BID ADDENDUM

PROJECT: MiraCosta Community College District
Project: SAN 400 & 900 Building Renovations
Bid # MM-20-020 ("Projects")

ADDENDUM NUMBER: 4 – B900

ADDENDUM NUMBER: 02

FOUNDATION
PLAN

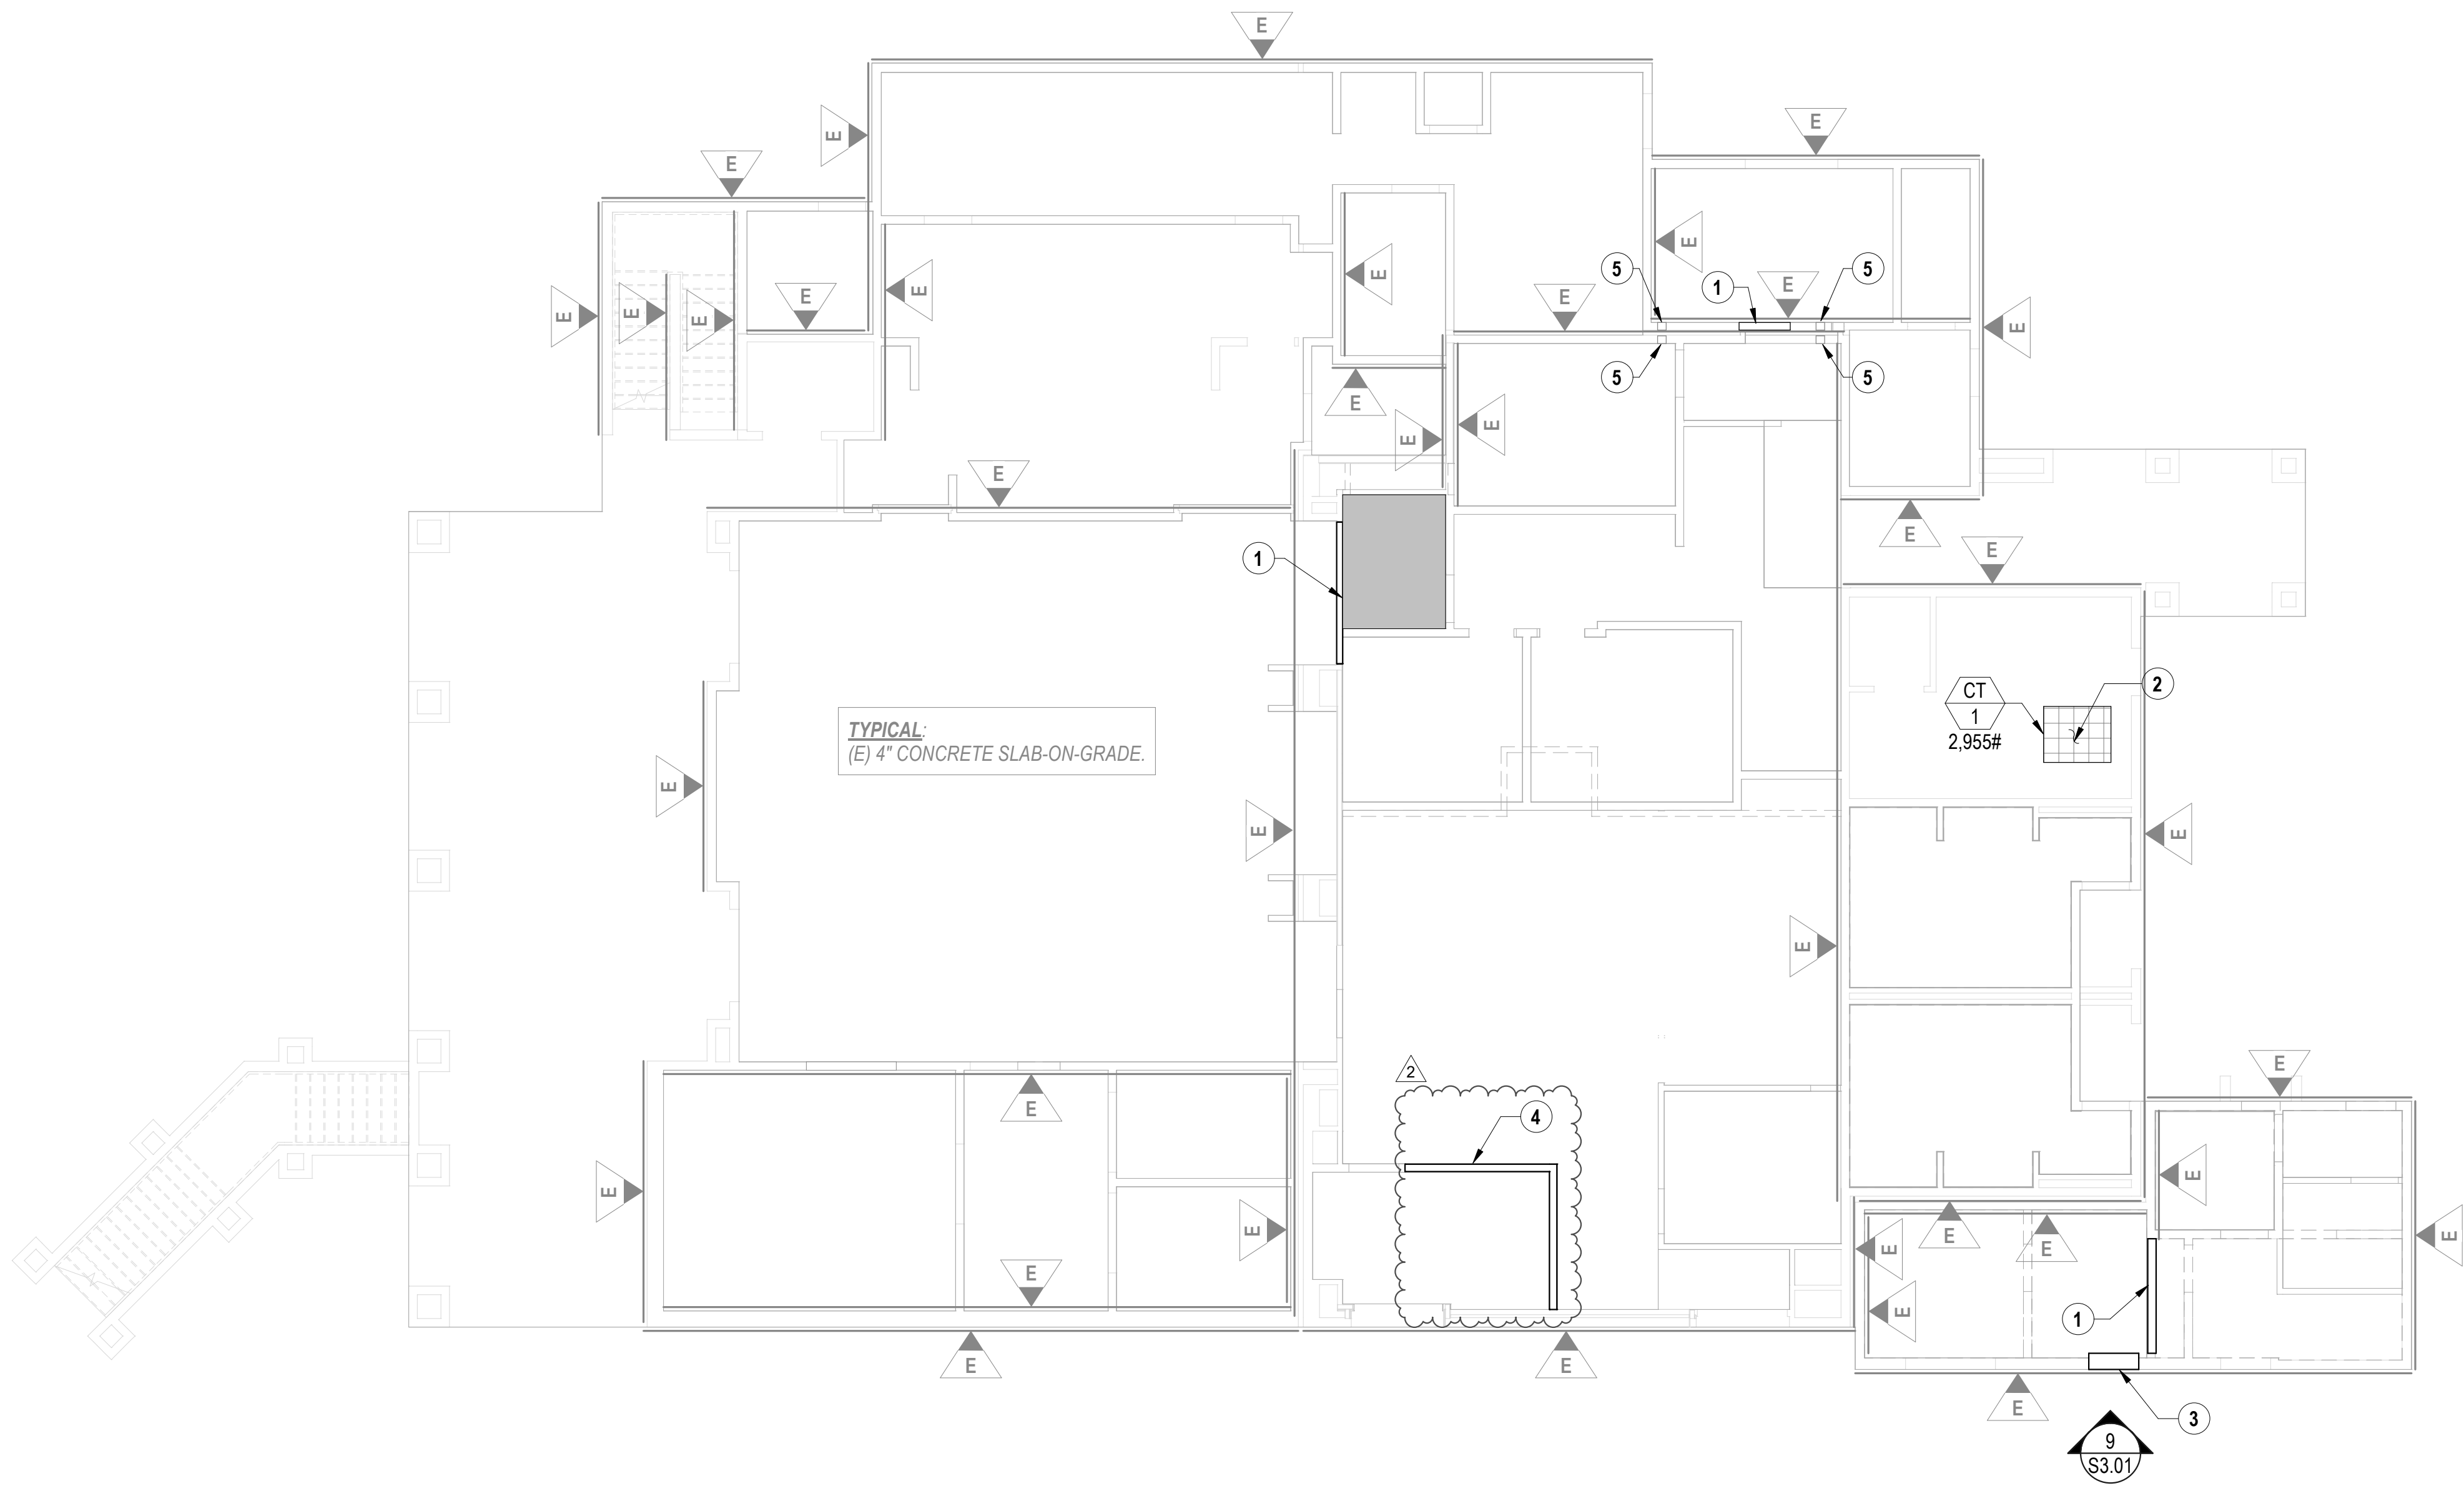
- S2.01
 - Revised Foundation Plan coordinated with Architectural set.
- S2.02
 - Revised Roof Framing Plan coordinated with Architectural set.
